**5/20/2026 | 6:00 PM**

**Municipal Services Center, Council Chamber  
3600 Tremont Road**

**Record No: 26-1031**

## Record No: 26-1385

**SITE PLAN, ZONING,  
 TOPOGRAPHIC AND  
 DRAINAGE PLAN**

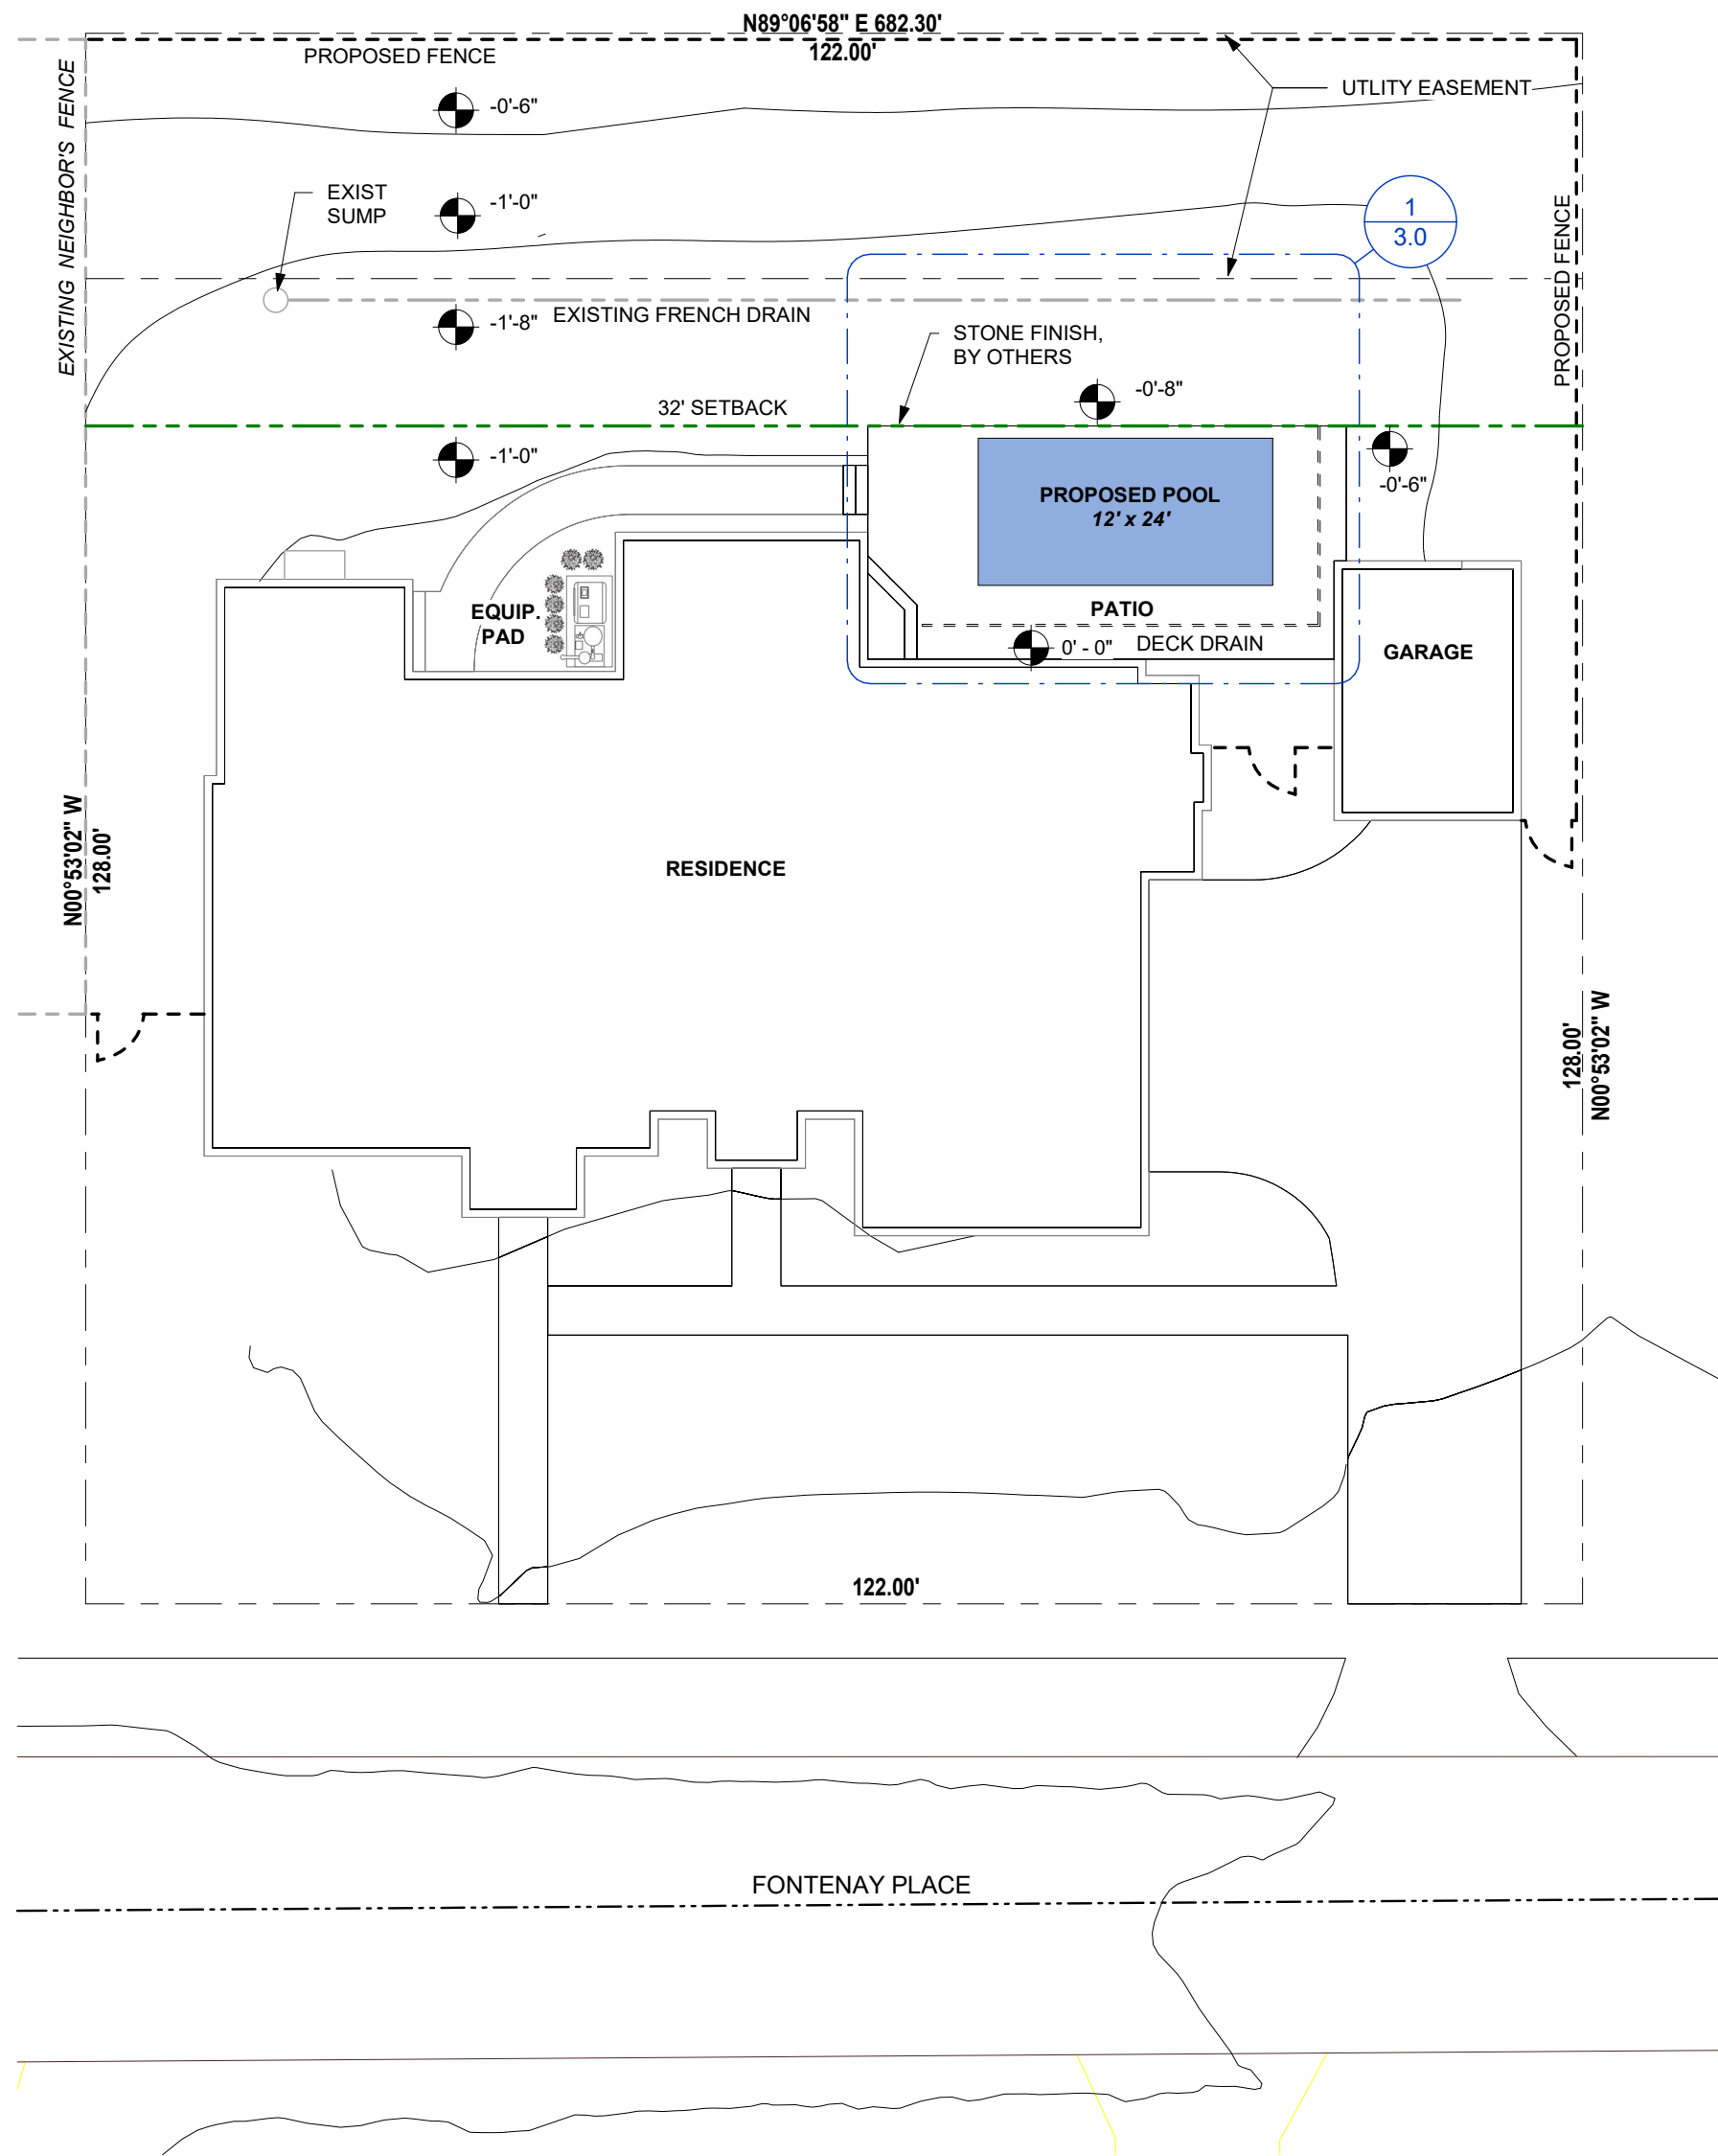
The City has been made aware of possible discrepancies between improvements authorized as part of the Certificate of Zoning Compliance (CZC) #22-3038 and Swimming Pool Permit #23-1416 for your property at 2082 Fontenay Place. Per CZC #22-3038 and Swimming Pool Permit #23-1416, the pool and all associated decking were appropriately located outside of the platted 32-foot rear yard setback. Recent aerial images from both the City of Upper Arlington's GIS and the Franklin County Auditor's Office appear to show additional improvements located within this platted rear setback (and possibly a utility easement), which is prohibited.

The final inspection for the pool occurred on October 19, 2023 and the pool was passed due to conformance with code and the approved plans. It appears that additional work may have occurred after this final inspection. Per Unified Development Ordinance (UDO) [Article 3.06](#) (Enforcement and Penalties) it is unlawful to locate, erect, construct, reconstruct, enlarge, change, maintain, or use any building or land in violation of any of the provisions of the UDO. Should violations exist, citations may be issued with daily fines assessed.

LAYOUT COVERAGE PLAN

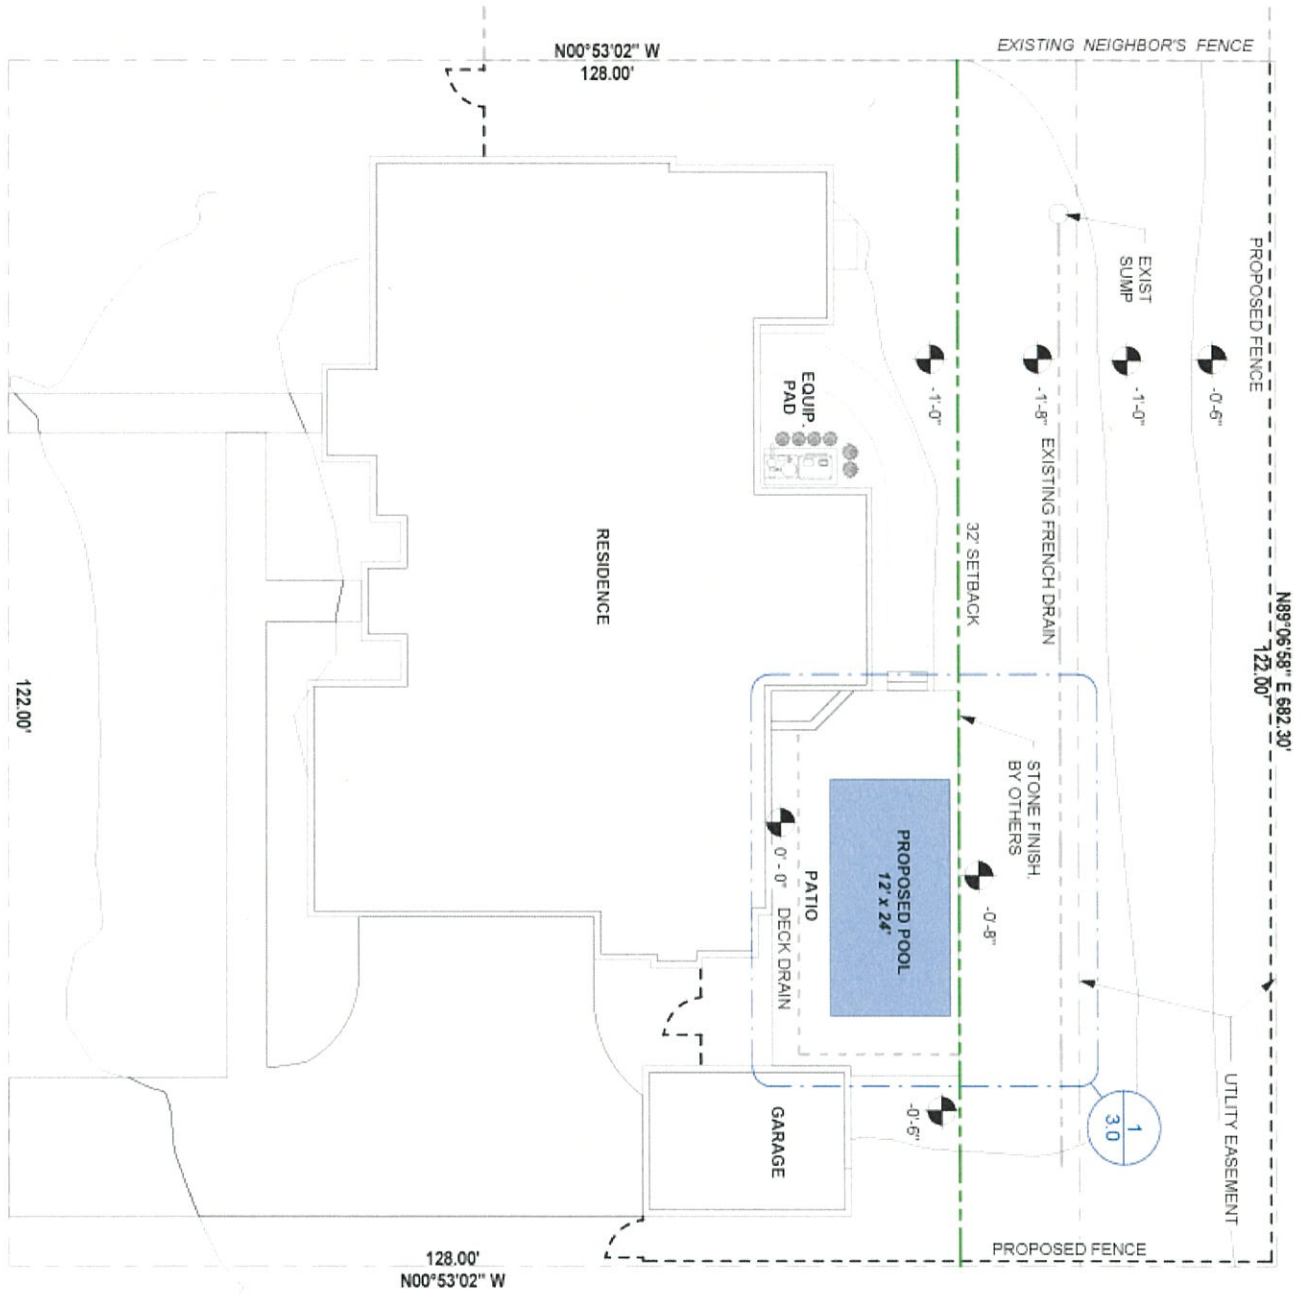
- Development cover exceeds the 45% maximum allowed in the R-1a District – UDO Article 5.02(C) [Table 5-F]
- Swimming pool and related decking encroach upon the platted 32’ rear yard setback – UDO Article 6.09(D)(11)
- Swimming pool decking encroaches the 10’ minimum side yard setback – UDO Article 6.09(D)(11)
- Swimming pool fence relocated/modified without a permit – UDO Article 6.09(D)(12) [also building code implications]
- Retaining wall constructed without a permit – UDO Article 6.09(D)(12) [also building code implications]
- Drainage improvements in an easement – [building code and engineering implications]

Today, Plat Amendment (#25-3177) remains in progress since its initial filing on July 1, 2025. A Variance Application (#26-1385) was filed on April 15, 2026, and is asking for an increase of the maximum development coverage to be increased from 45% (including 5% swimming pool “bonus”) to 50% to accommodate the increase of impervious surfaces added to the site by Martinez Landscaping performed in the fall of 2023. This work included landscaping and the installation of additional concrete decking which was done without a permit.
